# *City of Brisbane*

## *Planning Commission Agenda Report*

**SUBJECT:** **Variance V-1-19/Grading Review EX-1-19; 296 San Benito Road;** R-1 District; Variance and Grading Review to allow demolition of an existing single-family home and construction of a new 1,794.5 sq ft single-family home on a 2,300 sq ft lot, exceeding the maximum permitted FAR by 138.5 sq ft and requiring 95 cubic yards of soil cut and export; Jerry Kuhel, Kuhel Design, applicant; Paul M. and Glenda M. Jimenez, owner.

### Floor Area Ratio Variance Analysis

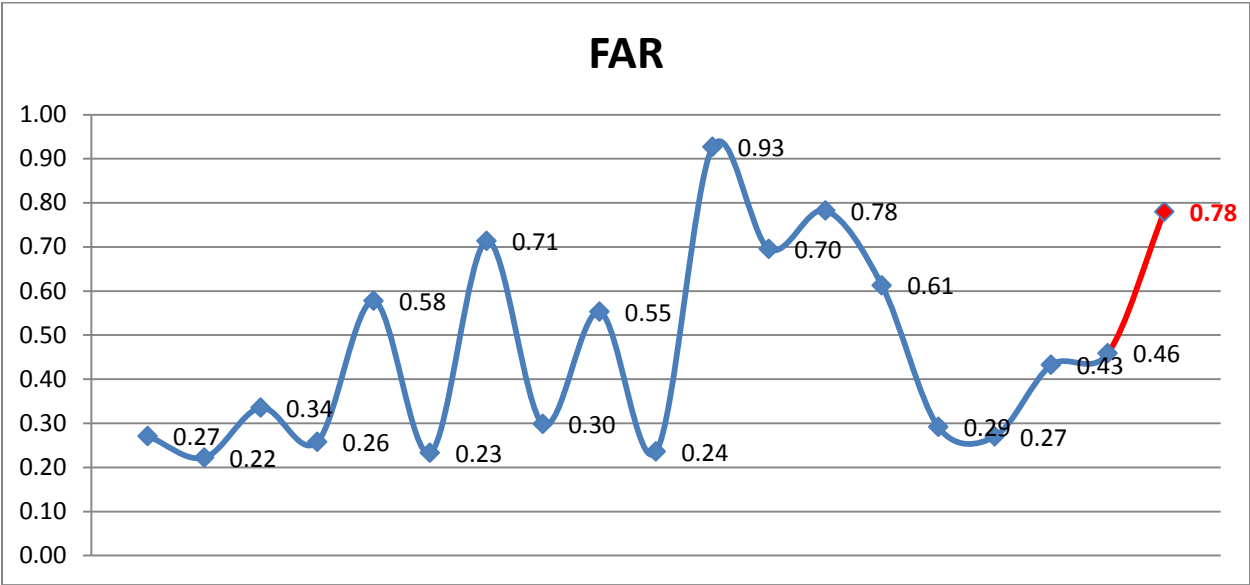
As previously noted, the subject property is substandard in regards to lot size, width, and depth (see applicant's Site Plan in Attachment E). The majority of lots in the vicinity are less than 5,000 sq ft in size, and the subject property is one of four lots in the vicinity less than 2,500 sq ft in size. (See Attachment E). Thus, while the lot is substandard in size, many lots in the vicinity are similarly sized or less conforming. As such, there are no special circumstances applicable to the subject property as compared to other properties in the vicinity.

CONCEPTUAL  
GRADING PLAN

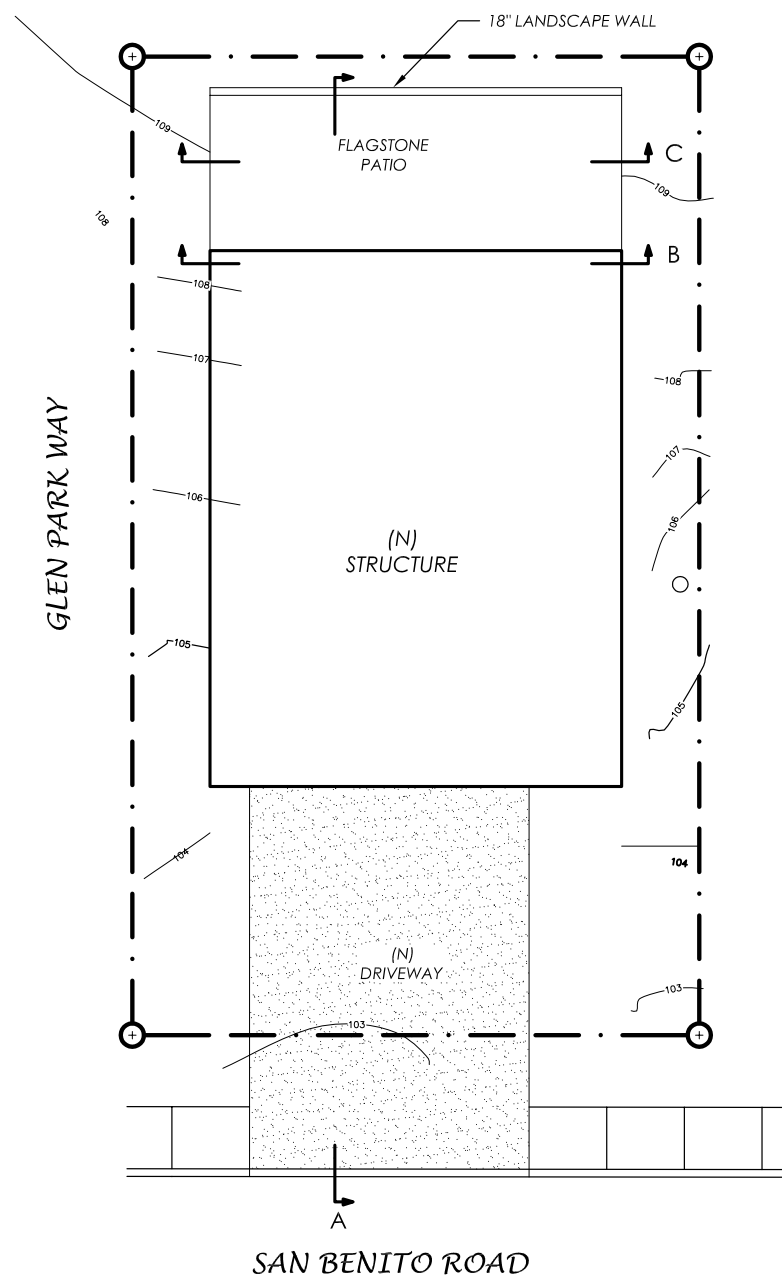
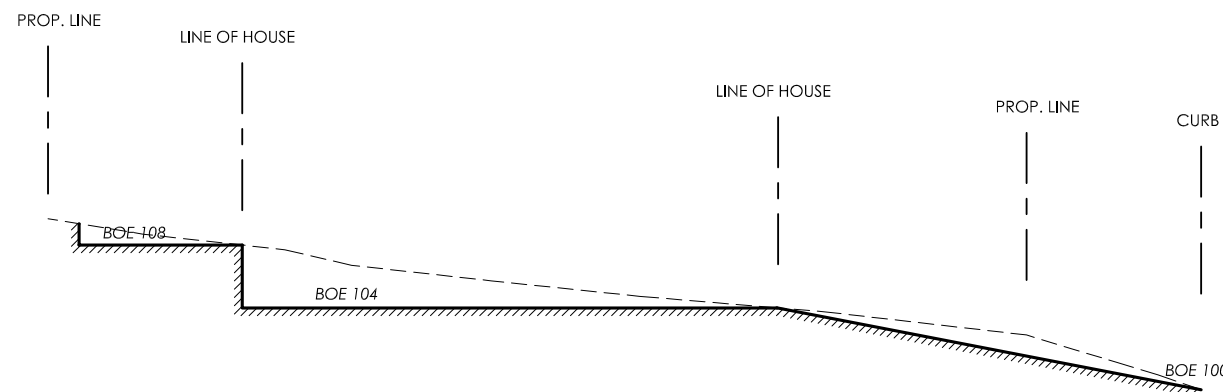
The subject property features an approximately 10% slope from the front to rear property line. As indicated by the applicant's conceptual grading plan and sections, 95 CY of soil excavation and export from the site is the minimum necessary to accommodate the new structure within the surrounding natural topography and provide required on-site parking. The City Engineer has reviewed and accepted the applicant's proposed driveway location on San Benito Road, with the condition that the curb cut on Glen Park Way be eliminated and restored as a curb and sidewalk.

- As indicated by the applicant’s grading plan and sections, the 95 CY of soil excavation and export from the site is the minimum necessary to accommodate the new structure within the surrounding natural topography and provide required on-site parking.

- The proposed grading would result in an exposed retaining wall at the north side of the home, of approximately seven feet in exposed height from grade, adjacent to the mid-level patio and outside of the required five-foot side yard setback.

3. The site plan and civil plans shall show elimination of the existing curb cut on Glen Park Way and restoration as a curb and sidewalk per the Department of Public Works’ standard details, subject to review and approval by the City Engineer.

FLOOR AREA  
CALCULATIONS

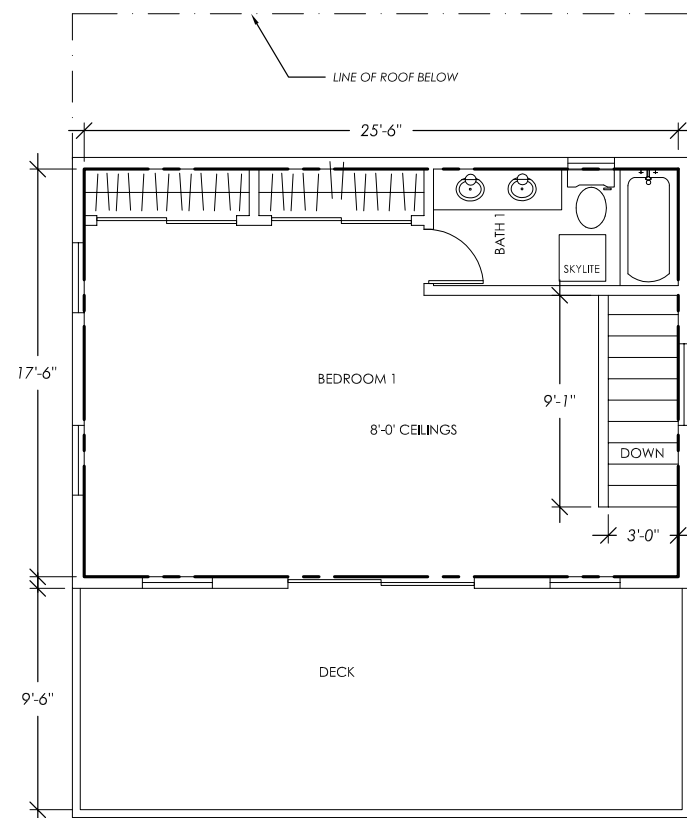
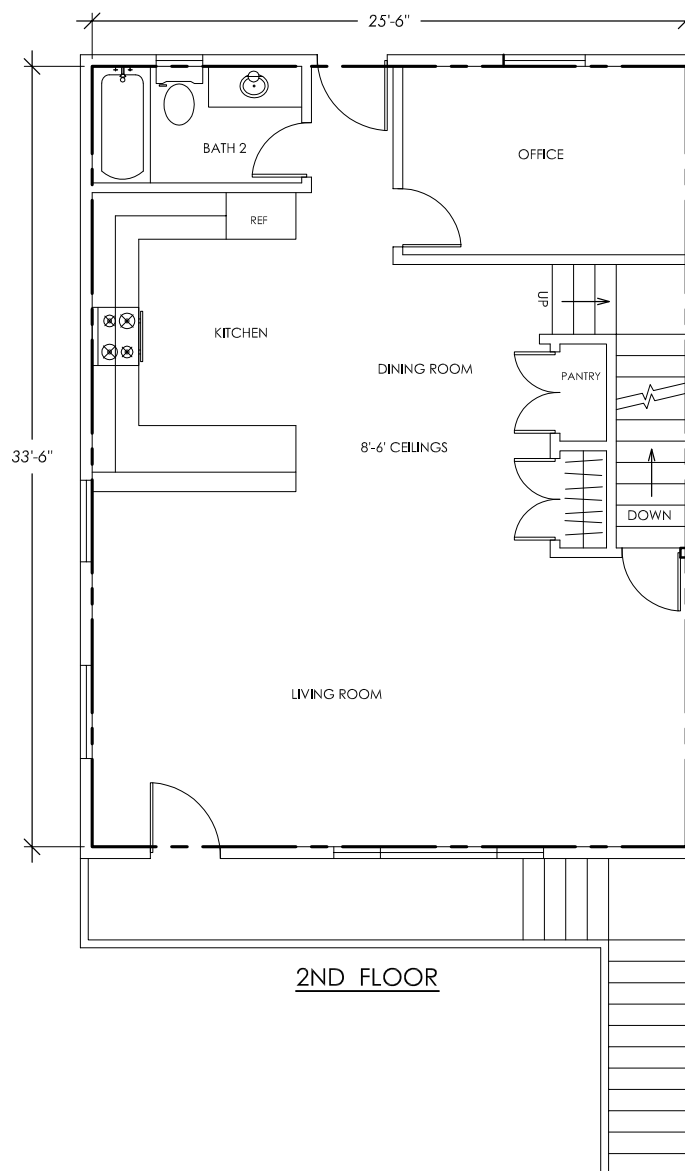
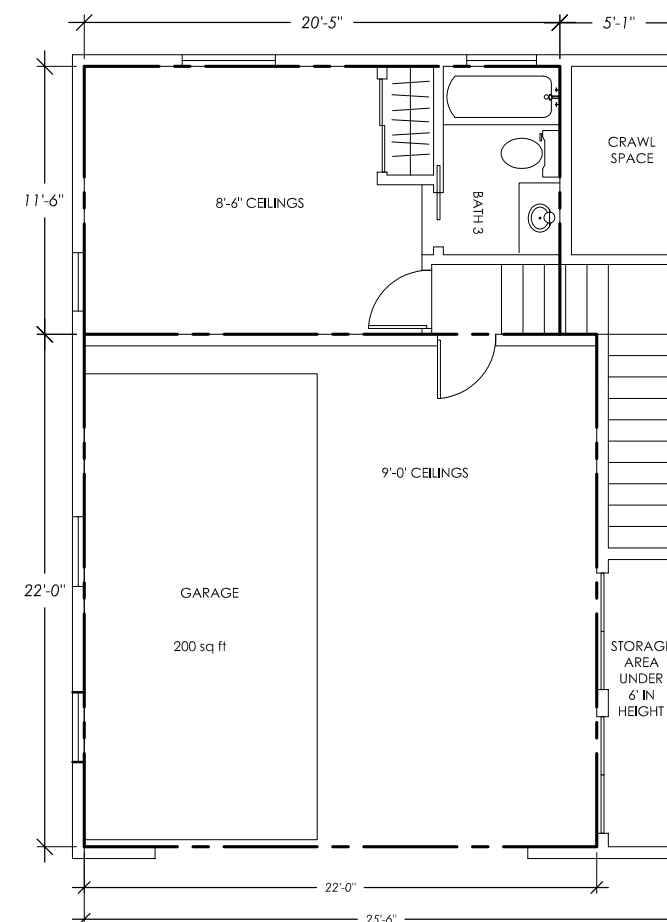
In the R-1 zoning district, the maximum FAR of 0.72 is sufficient to allow most substandard lots (2,500 sq ft or more) to accommodate 1,800 sq ft of living area and one covered parking space. A one-car garage is 200 sq ft, per the design standards in BMC §17.34.040.G.1, correlating with the 200 sq ft reduction in floor area allowed by BMC §17.06.040.F for substandard-sized properties. For the proposed home size of 1,521 sq ft (and any home under 1,800 sq ft of living area), BMC §17.34.020 requires only one covered parking space and two uncovered parking spaces. In this particular case, the applicant is requesting an FAR Variance to accommodate an additional covered parking space beyond the one space required by the parking ordinance. The project plans call for a 473 sq ft garage, which exceeds the minimum dimensions and area for a two-car garage by 73 sq ft and exceeds the covered parking requirement by 273 sq ft.

By uniformly applying the 200 sq ft FAR reduction for covered parking for substandard lots, the R-1 regulations recognize that substandard lots are disproportionately impacted by the covered parking requirements than standard lots. The 200 sq ft exemption allows more floor area to be dedicated to living area for people rather than parking areas for cars. The ability to provide a two-car garage where it is not required by the parking ordinance while otherwise maximizing living space is thus not a privilege enjoyed by other substandard lots in the R-1 district.

1. The residential structure shall comply with all development standards of the R-1 zoning district, including but not limited to FAR, lot coverage, and building height maximums, setback minimums, and required on-site parking.
